Response to a Request for Additional Information Regarding Request for Relief
No. 11 for the Unit 1 3rd 10-year Interval Inservice Inspection Program (TAC No. MB2199)

TECHNICAL LETTER REPORT
REQUESTS FOR ADDITIONAL INFORMATION
ON THIRD 10-YEAR IN-SERVICE INSPECTION INTERVAL
REQUEST FOR RELIEF
FOR
NUCLEAR MANAGEMENT COMPANY
PRAIRIE ISLAND NUCLEAR GENERATING PLANT, UNIT 1
DOCKET NUMBER: 50-282

2.1 Request for Relief No.11, for “limited examinations” associated with Third 10-year Interval Program Plan Issued on February 22, 1996.

Report No.: 2001U039
Page: 2 of 3

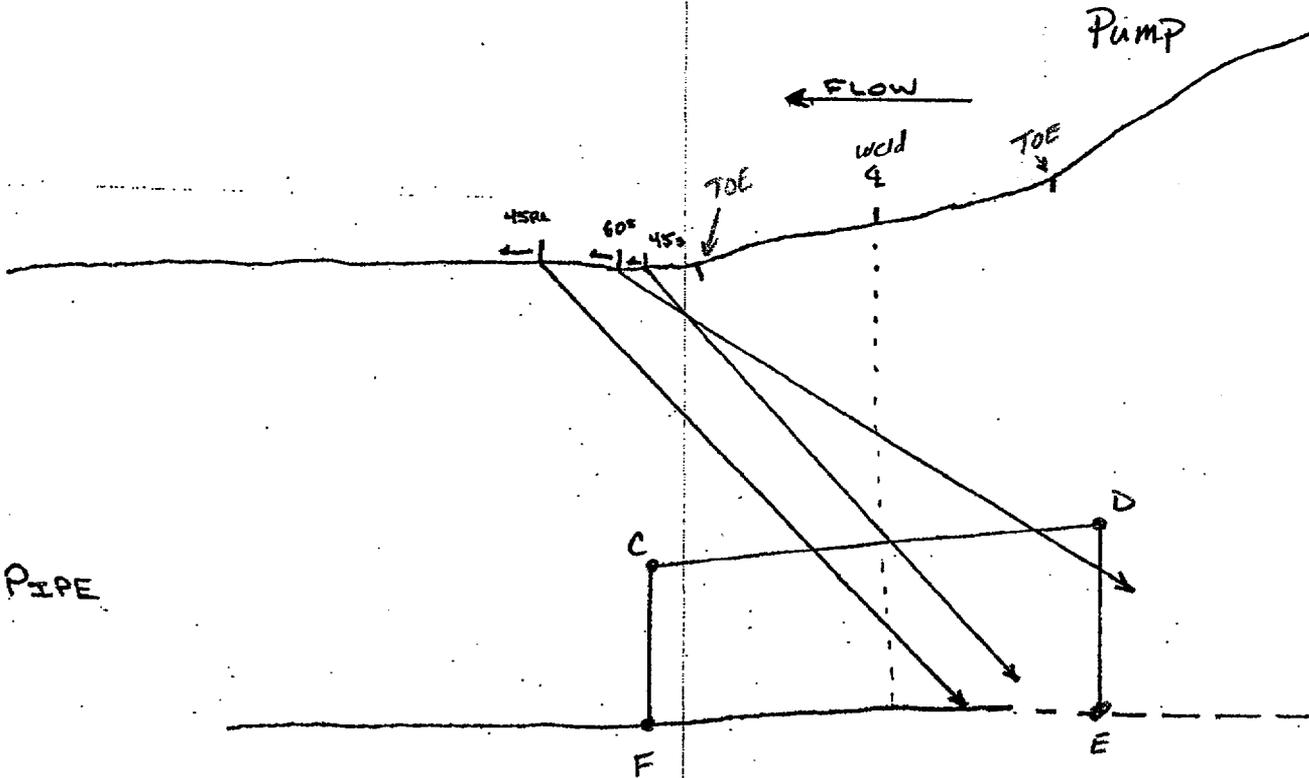
- (1) Table 1 of the licensee submittal indicates that the limitation for the weld W-6 is (PDI) single sided examination due to pipe configuration and for the weld W-1 is (PDI) single sided examination due to pump to pipe configuration. The sketches provided in the associated summary sheets are not clear to understand these limitations. Explain with sketches or photos what kind of configuration problems are associated with each of these welds. Discuss the relationship of the configuration limitations with PDI and provide the reference of the PDI section.

CONTOUR precludes EXAMINATION
UP STREAM OF CENTER LINE

Response: No photos of these limitations are available. The limitations for W-1 and W-6 are related to contour configuration of the OD scan surfaces that precluded a four directional scan of the weld volume particularly from the valve side (W-1) or pump side (W-6) of the weld, which is shown on the sketches previously submitted and new sketches (Attachments 1 and 2).

Sketch or Photo: G:\NIDDEAL50\PH1RFO2001\UT - Supplemental\2001U004-1.bmp

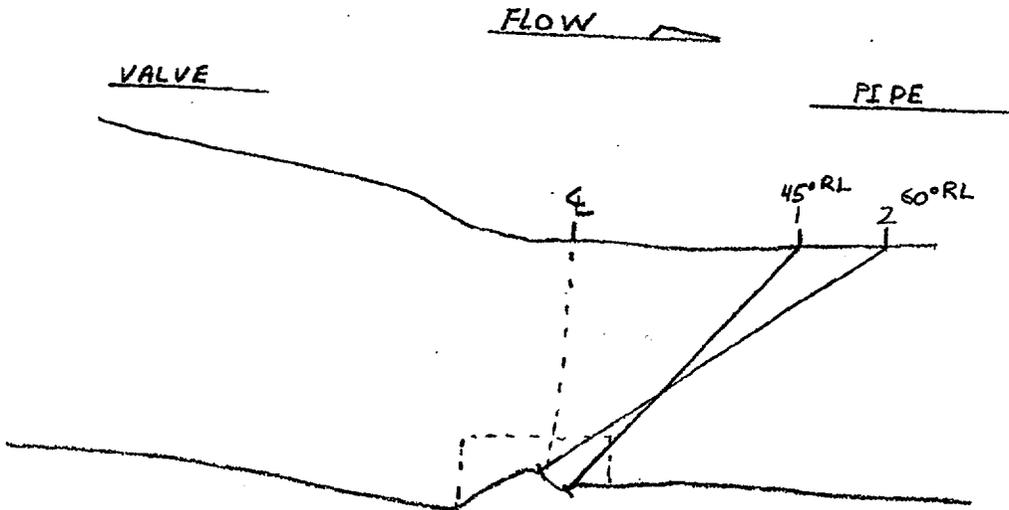
- (2) The description in the Table 1 of the licensee submittal identifies the weld W-6 is a circumferential weld between the RC pipng to elbow, while the sketch in the corresponding summary report No. 300130 indicates that the weld is for the pipng to valve. Clarify this discrepancy.

CONTOUR OF VALVE SURFACE
precludes examination coverage
upstream of weld zone.

Response: The Table 1 entry is incorrect and should say "Piping to Valve" as indicated on inspection report and sketch (Attachment 2). The limitation coverage for W-1 is also incorrect and should be 50% Coverage. These have been entered into the plant corrective action process.

Sketch or Photo: G:\DDEAL50\PH1RFO2001\UT - Supplemental\2001U010-2.bmp

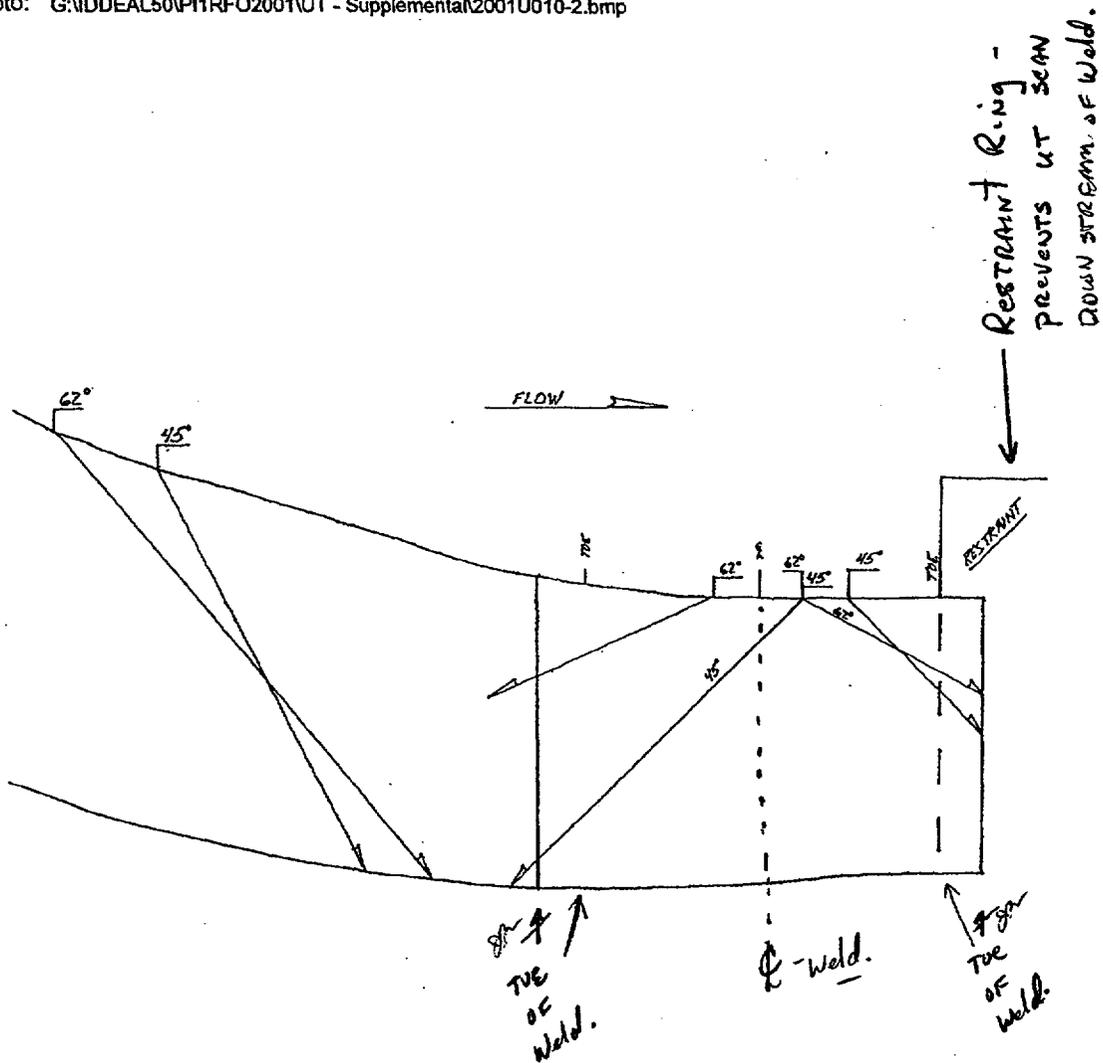
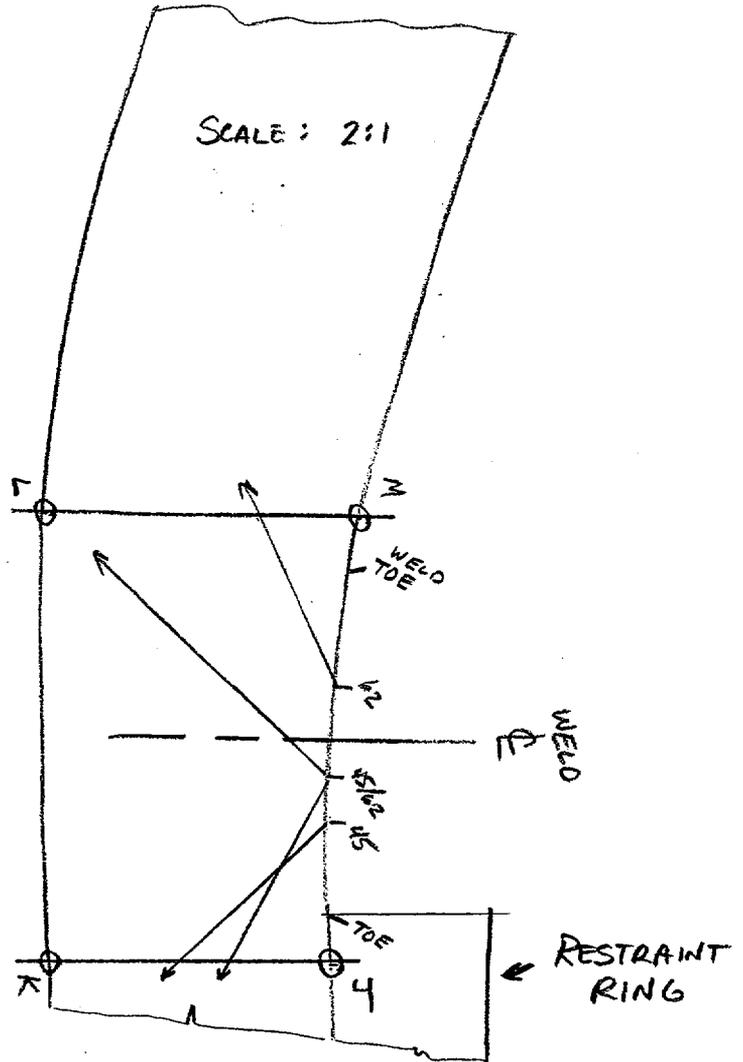
- (2) The sketches given in Summary Nos. 301070 and 303054 are not clear. Provide sketches showing the Code-required volume to be examined and the scanner locations with volume coverage as practical.

REQUIRED
VOLUME
BETWEEN
J, K, L, M

RESTRAINT RING WOULD BE
IMPRACTICAL TO REMOVE.

Response: Attached are UT reports 2001U010, 2001U029 and associated sketches (Attachments 3 and 4) and ISI-93B diagram of W-2 (Attachment 5). The UT coverage indicated on Table 1, of 70.88% for Weld W-E is incorrect and should state 77.54% coverage. This has been entered into the plant corrective action process. Weld W-E downstream UT scan is inaccessible due to restraining ring around Steam Generator. For W-2 flange, contour surface prevents adequate scan coverage downstream.

ISI-51B

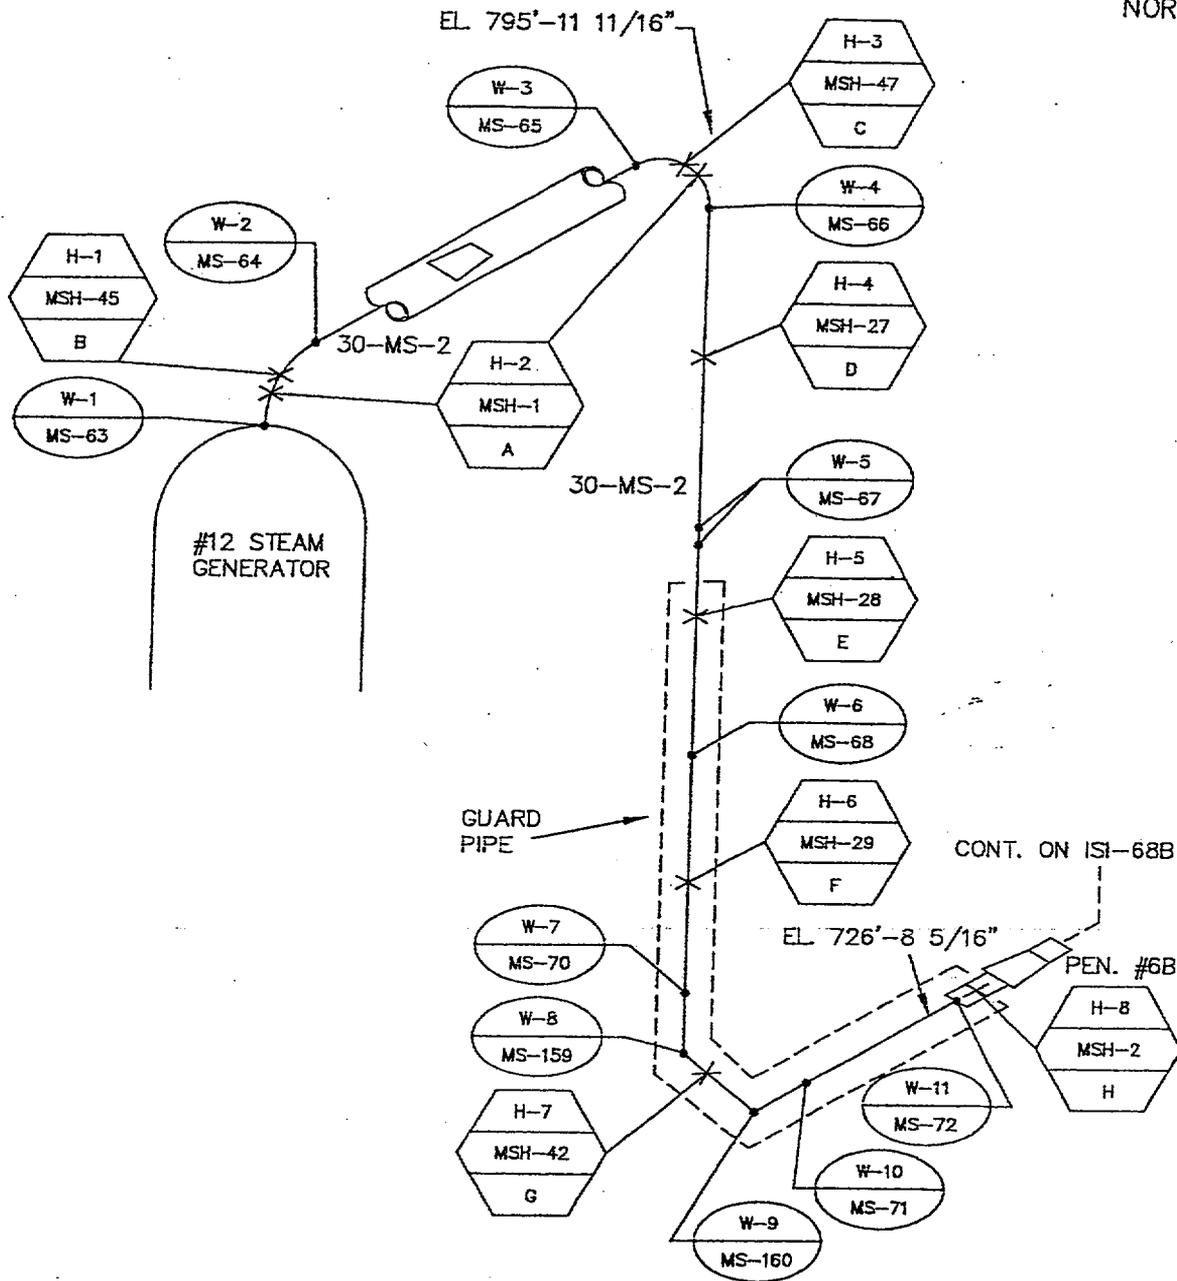
- (2) The diagrams given in the Limitation Record sheets are not clear, specifically the surface areas to be examined and the inaccessible portions of the weld. Some are covered by guard pipes and the licensee submittal for these welds include only the Magnetic Particle Examination sheets and no sketches or diagrams. Please provide detail sketches or photos with sufficient details so that the staff could determine the interferences on accessing the Code-required surfaces for the subject welds.

Response: Guard piping completely encloses the weld areas. See attached Isometric drawing ISI-51B, ISI-68-A, and ISI-69 (Attachments 6, 7, and 8) for location of Guard Pipe. Photograph of guard pipe not available.

Site/Unit: NSPI PI 1 Procedure: ISI-MT-1 Outage No.: PIIRF2001
 Summary No.: 301258 Procedure Revision/FC: 11 1 Report No.: 2001M034
 Workscope: 151 Work Order No.: 0010296 Page: of

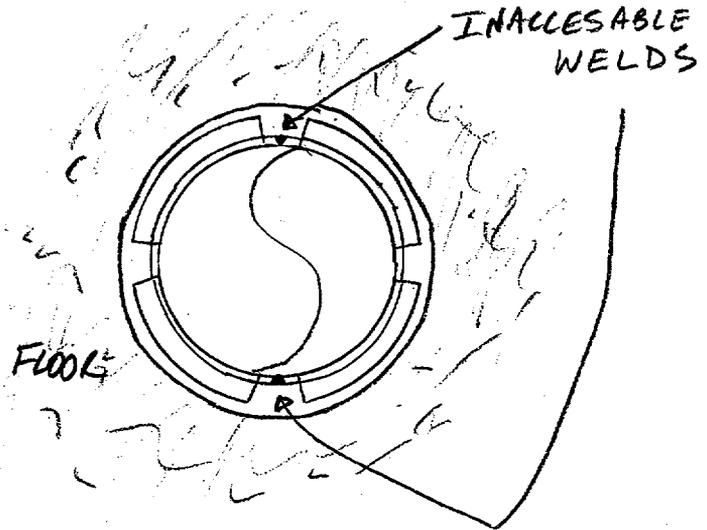
- (b) Summary No. 301258 shows floor penetration which prohibits examination of the middle 12" of the two vertical welds on the pipe collar. The drawings do not clearly demonstrate the subject welds (2 circumferential welds and 2 vertical welds) and inaccessible portions of these welds. Please provide new sketches or photos showing the welds with inaccessible portions.

INACCESSIBLE AREA (TYPICAL 2 PLACES)

Response: There is no photo available. A new sketch is provided and examination report 2001M034 (Attachments 9 and 11).
